# UNITED STATES PATENT AND TRADEMARK OFFICE

10/687,921

<b>Office Action Summary</b>	Application No. 10/687,921	Applicant(s) SU ET AL.	
	Examiner William L. Boddie	Art Unit 2629

### **DETAILED ACTION**

FIG. 8

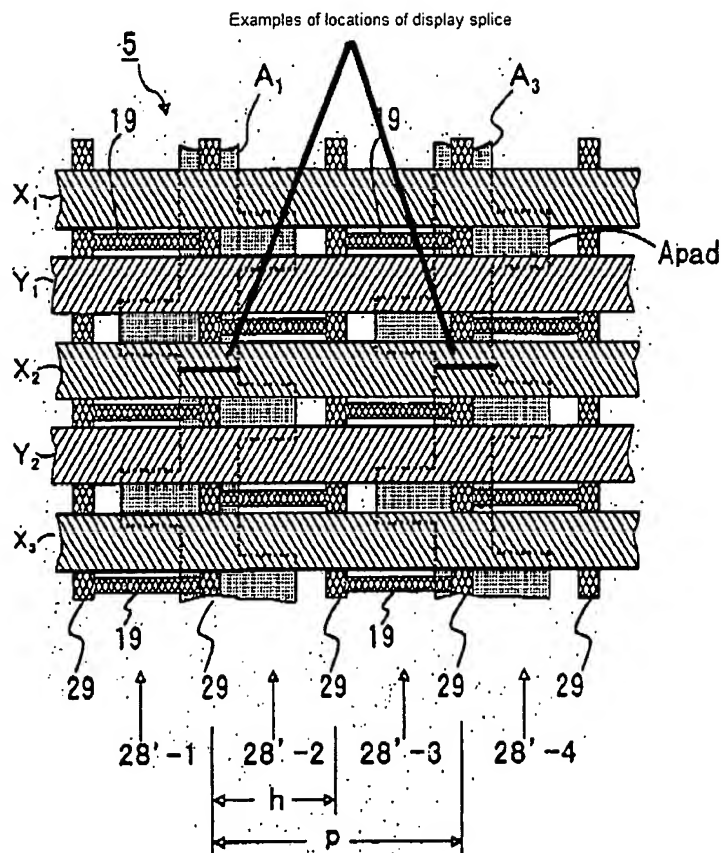
**With respect to claims 1 and 3**, Kosaka discloses, a plasma display panel with barrier ribs (29 and 19 in fig. 8) configured in a closed shape (rectangle in fig. 8) comprising:

a plurality of data electrodes (A1, A3 in fig. 8) overlapping a wall of said barrier ribs in a column direction (29 in fig. 8), each of said data electrodes extending under said cell area (clear from fig. 11); wherein

a dual scan gap (clear from fig. 12) of predetermined gap length is formed between a pair of said data electrodes (A1, A3 in fig. 8) in the column direction and at least partially overlapping the barrier ribs in a column direction (clear from fig. 8), and

a gap is formed between said row barrier ribs and said data electrodes, and said gap is positive or negative (clear from figs. 8 and 12), wherein said gap is less than 40% of the cell length (see discussion below).

From figure 12 it is clear that the alternating protrusions of the data electrodes continue from one side of the panel to the other. With this in mind, we turn to figure 8, where when the data electrodes are split it should be clear that there would be a gap between the row ribs, 19, and the data electrode that is less than 40% of the cell length. See the below annotated figure for further explanation. It is clear to the Examiner that upon splitting the electrodes there will be a gap of less than 40% between the row oriented ribs and data electrodes.

With respect to claim 4, Kosaka discloses, the panel of claim 1 (see above), wherein said gap length is smaller than said cell length (see above) and said gap length crosses over one of said row barrier ribs (clear from fig. 8).

With respect to claim 5, Kosaka discloses, the panel of claim 1 (see above), wherein said data electrodes has an expanded portion in said cell area (clear from figs. 8 and 11).

**With respect to claim 16**, Kosaka discloses, a plasma display panel with barrier ribs (29 and 19 in fig. 8) configured in a closed shape (rectangle in fig. 8) comprising:

a dual scan gap (clear from fig. 12) of predetermined gap length is formed between a pair of said data electrodes (A1, A3 in fig. 8) in the column direction and said dual scan gap under barrier ribs (clear from fig. 12).
